UNITED STATES OF AMERICA
NUCLEAR REGULATORY COMMISSION

MEETING ON RECALCULATION OF
SEISMIC RESPONSE SPECTRA:
COMANCHE PEAK

Location: Bethesda, Maryland
Date: Tuesday, June 18, 1985

AUXILIARY BUILDING
FLOOR RESPONSE SPECTRA
FSAR vs RSI RE-ANALYSIS

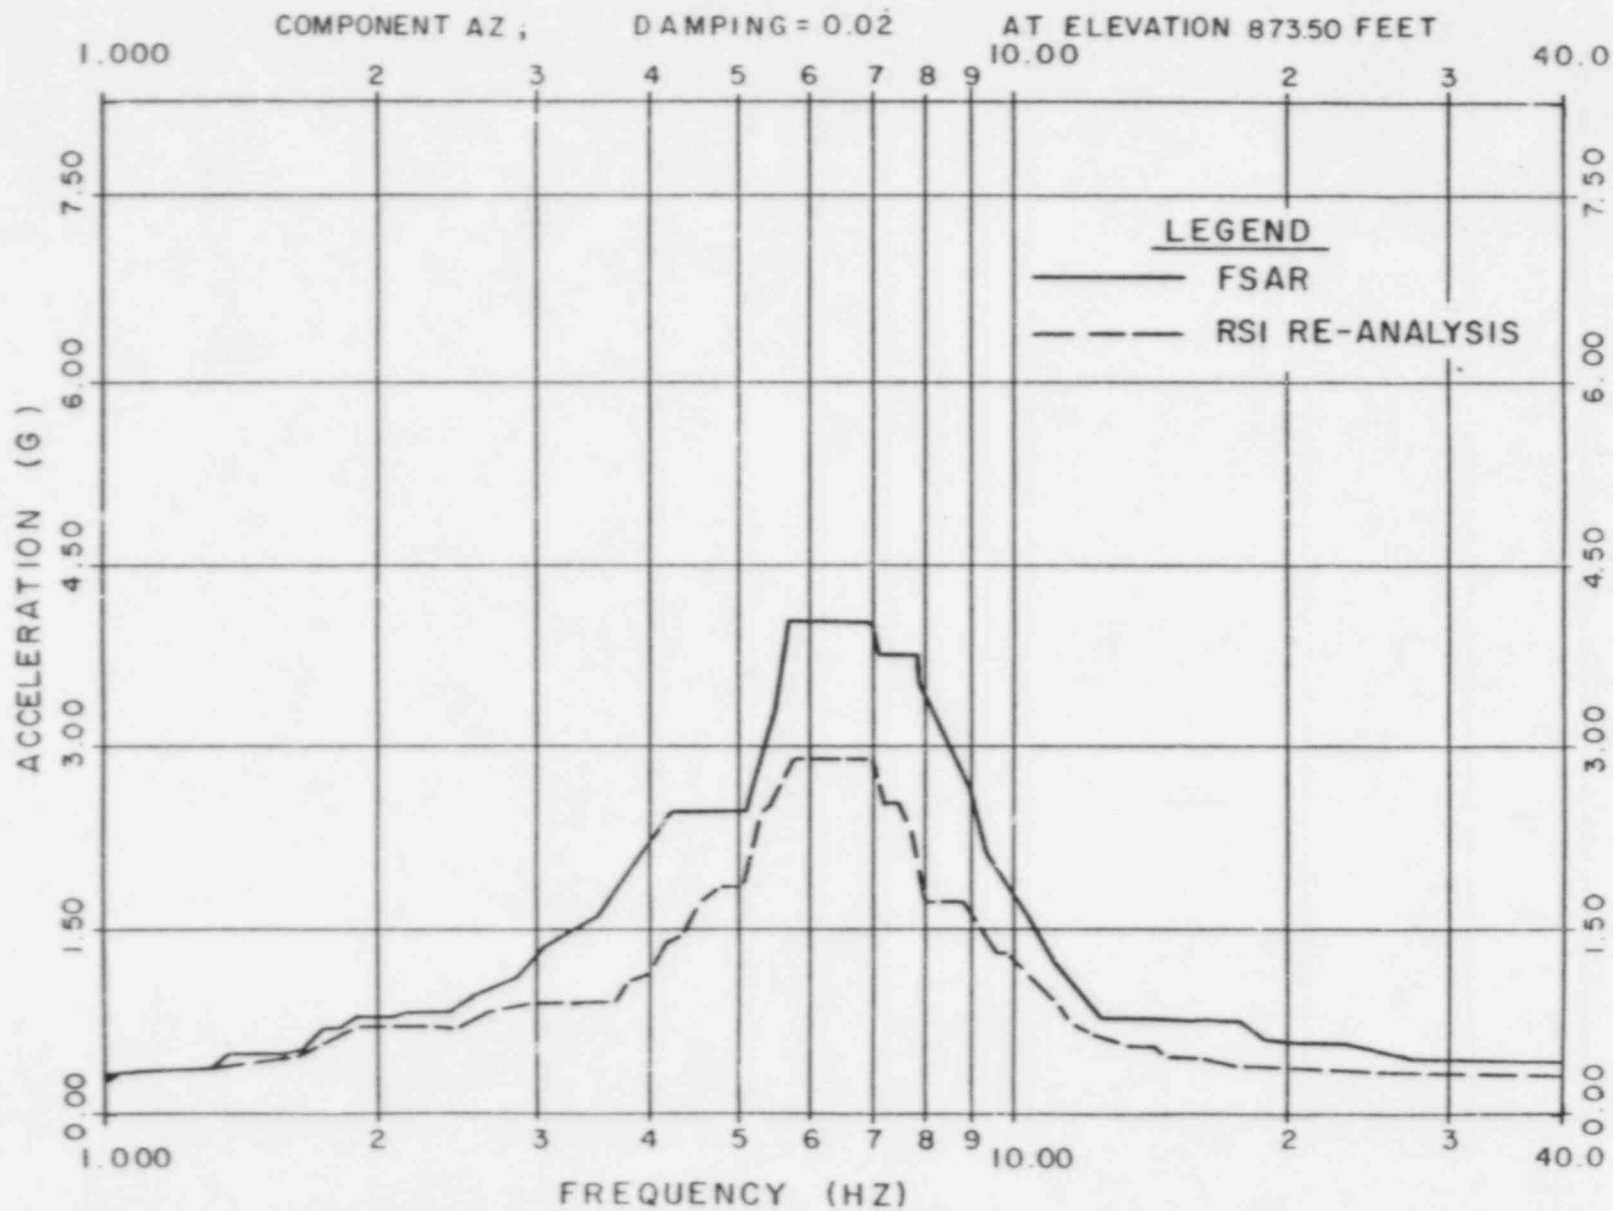
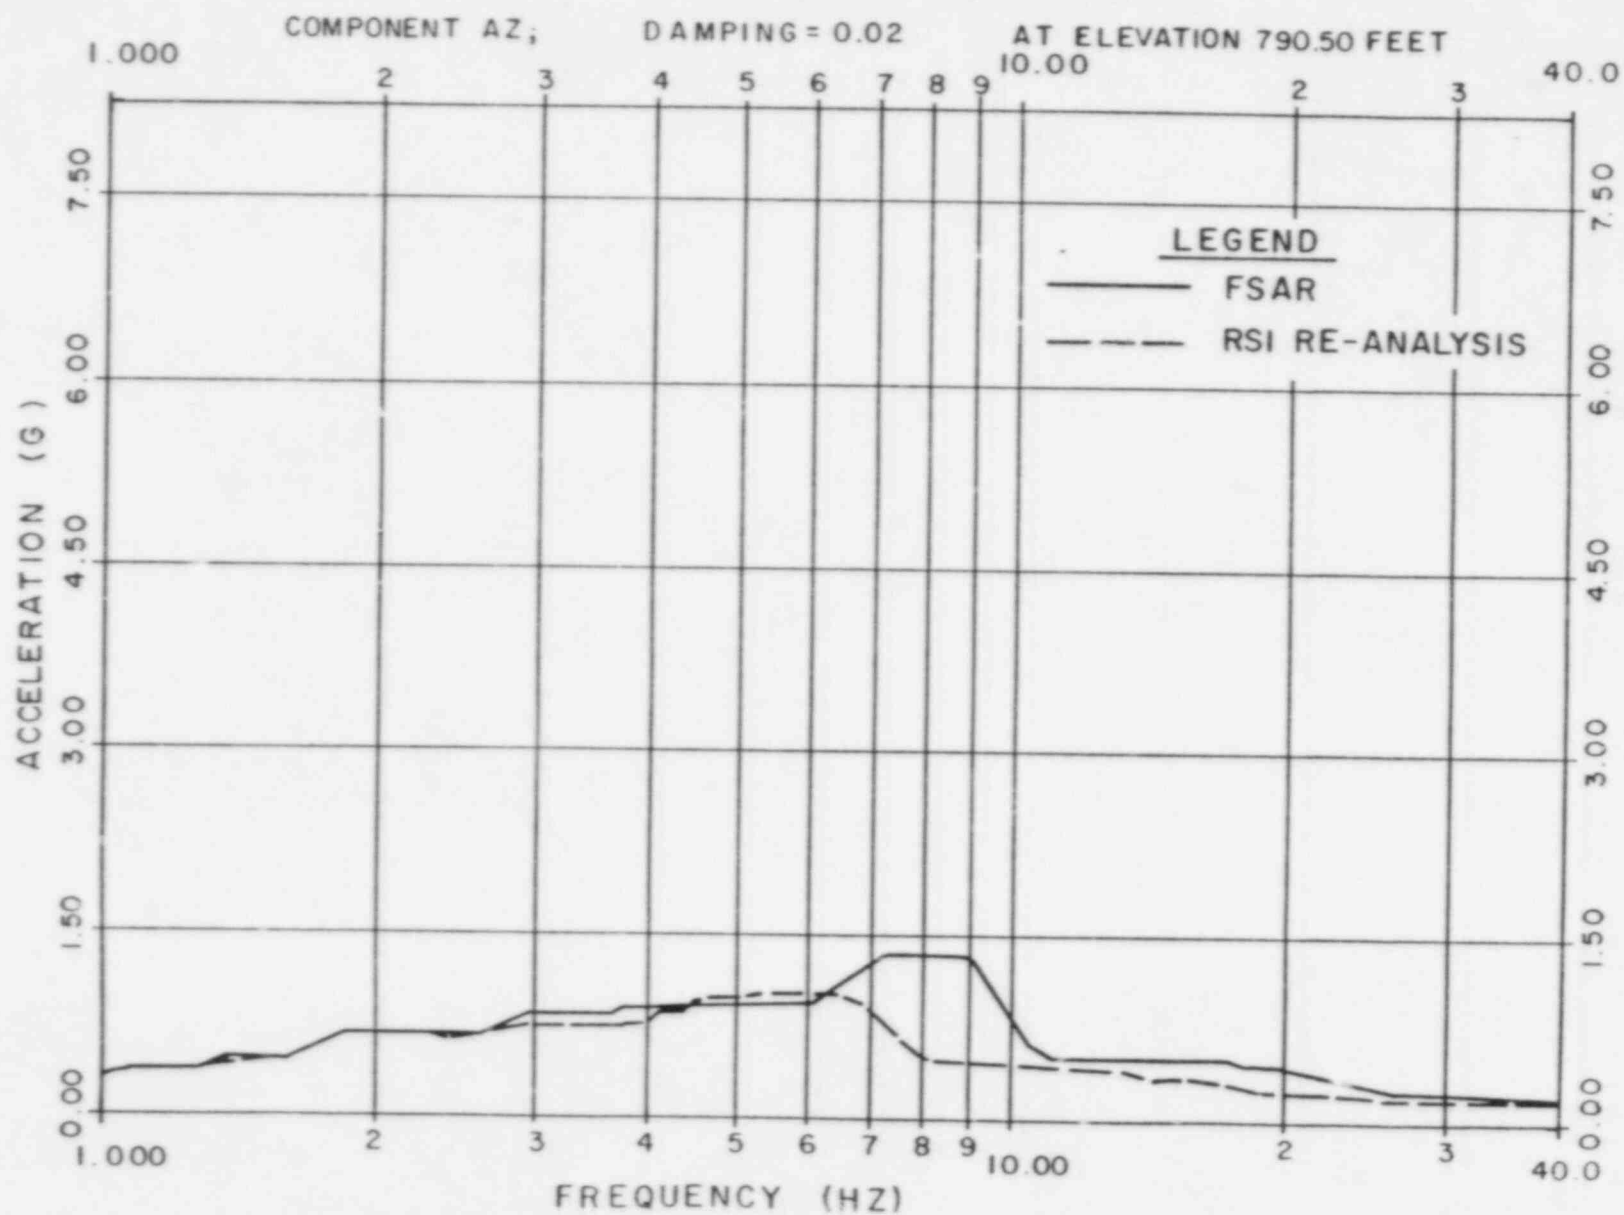
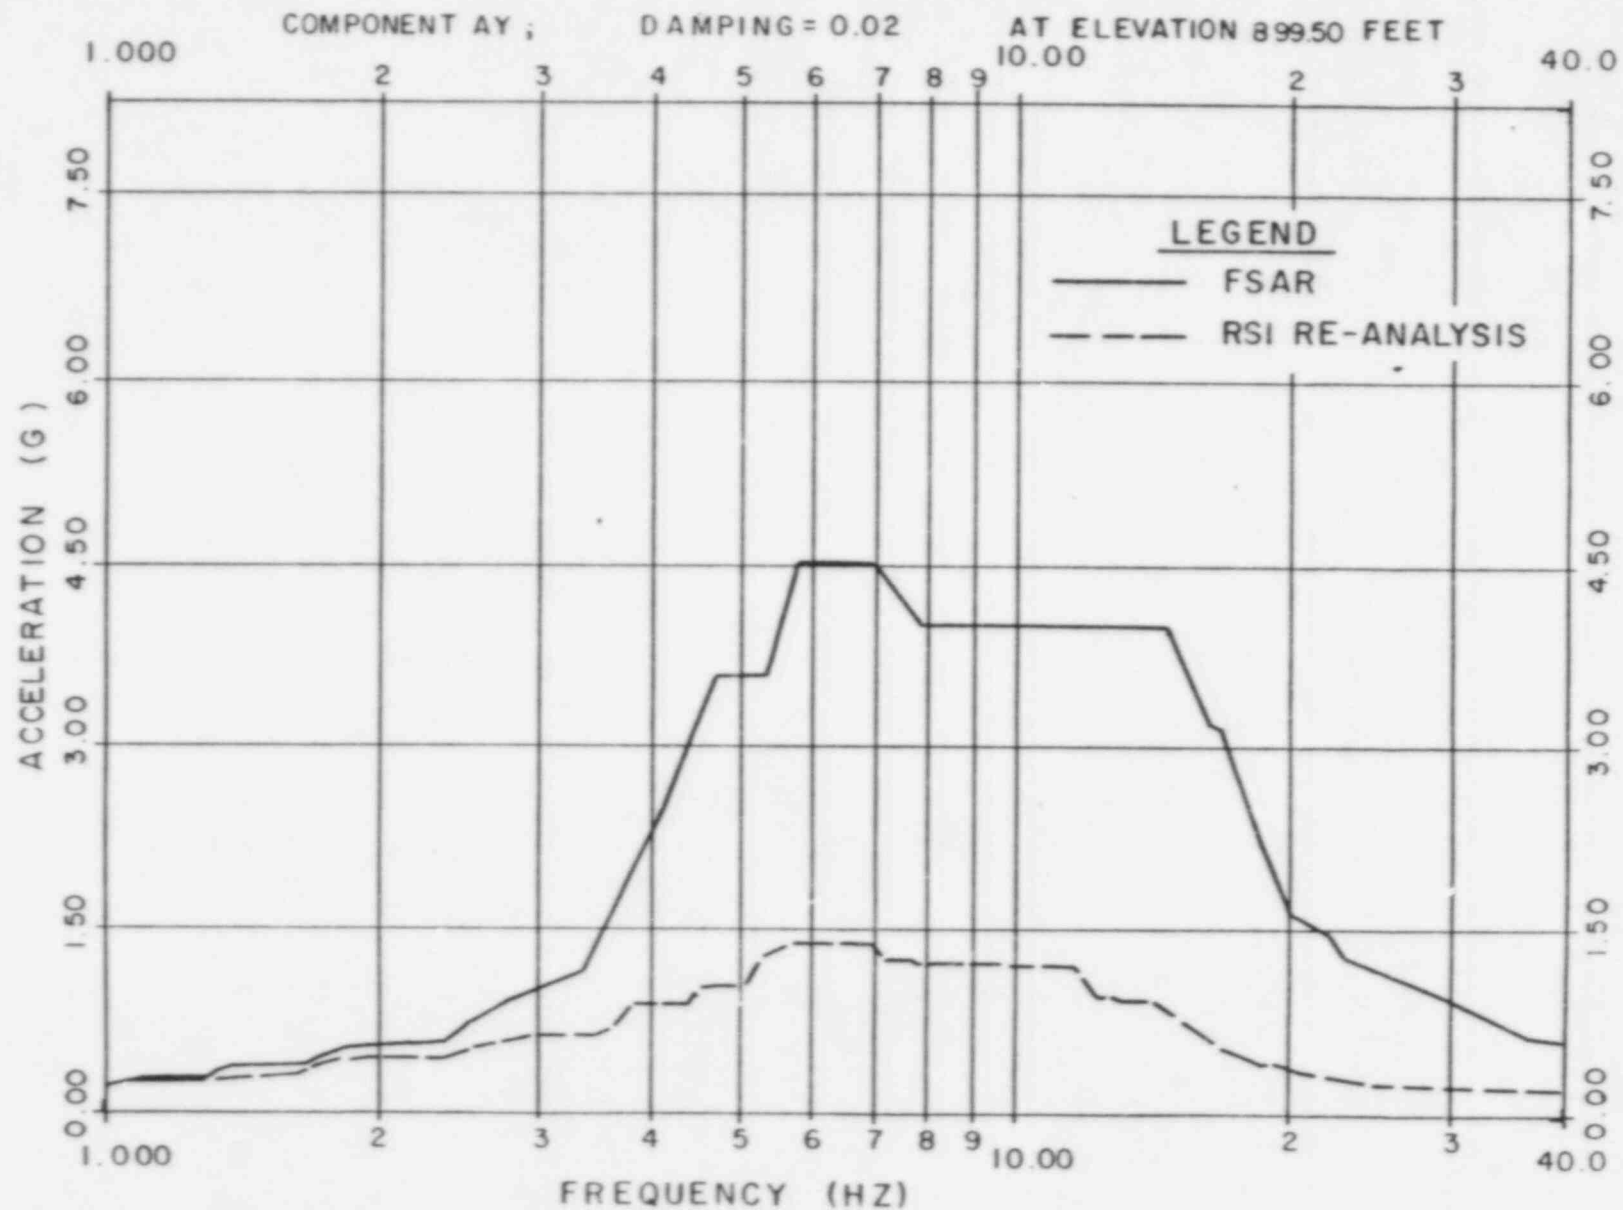
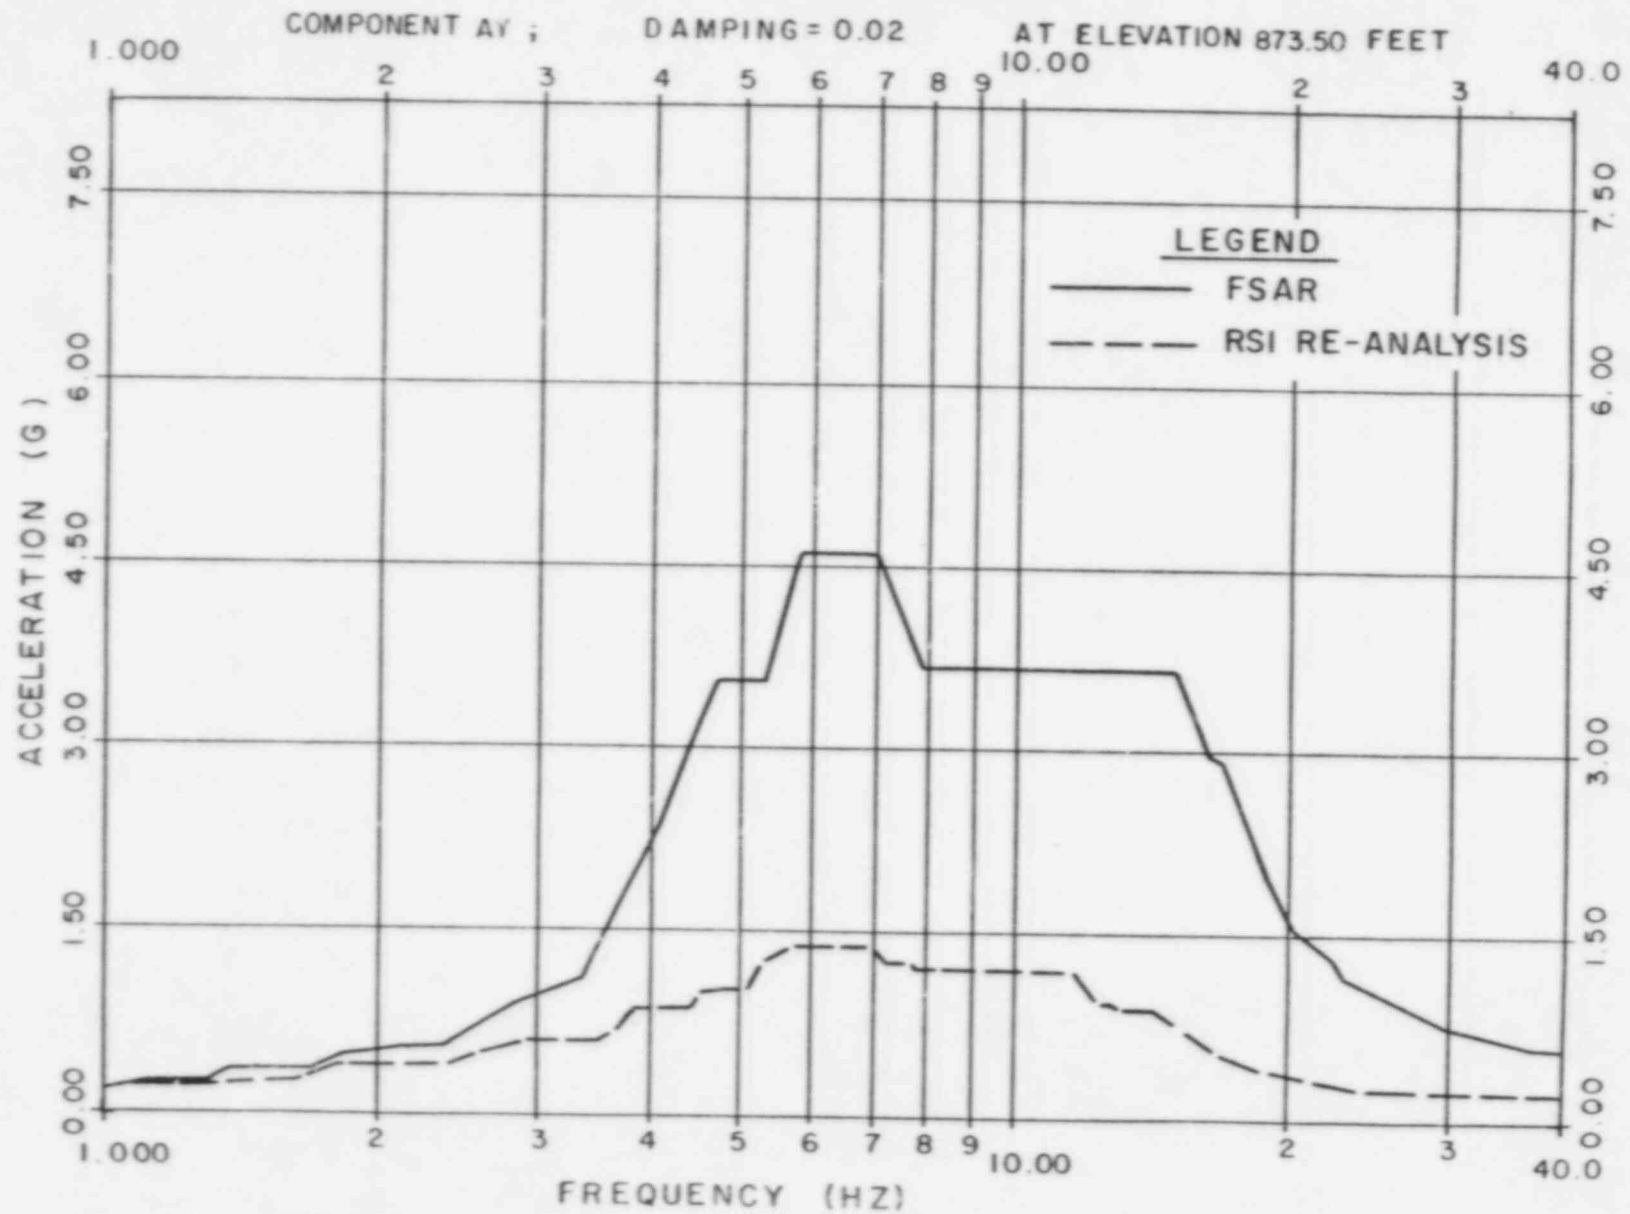
16 The line on this plot, the response spectra
17 previously defined from the FSAR is the solid line. The dashed
18 line is the results of this reanalysis. Comparing the peaks,
19 for example, is an indication of the margin that exists from
20 the analysis. This number basically is about 5.6 versus 3.7,
21 3.8 reduction in peak motion.

22 Now, in response to Larry Shao's comment earlier,
23 you can see that across this particular elevation, this
24 particular direction, we are below our previous response
25 spectra at all points except here [indicating], at about 1.8

16 Here the frequency shift occurs. We have a slight
17 overage on the response spectra.

16 MR. RINALDI: I have two short questions. One, you
17 refer to peak broadening. You use plus and minus 10 percent.
18 I want to caution you that the new requirement is 15 percent
19 unless you can prove otherwise. Just a comment.

20 The other thing is a question basically on the
21 spectra you showed for 2 percent damping. Can you comment on
22 5 percent damping? Is there significant change from what you
23 show?

18 MR. CLOUD: On the issue of the peak broadening, I
19 guess we have felt that the Standard Review Plan was slightly
20 different than you stated it. We felt that it called for 15
21 percent, but that 10 percent would be acceptable, provided it
22 was justified with additional studies.

2 In our view, that satisfies this approach
3 (indicating). Any reasonable method for determining the
4 amount of peak widening, and we add 10 percent on top of
5 that. It says "plus or minus." We take 10 percent on top of
6 the widening.
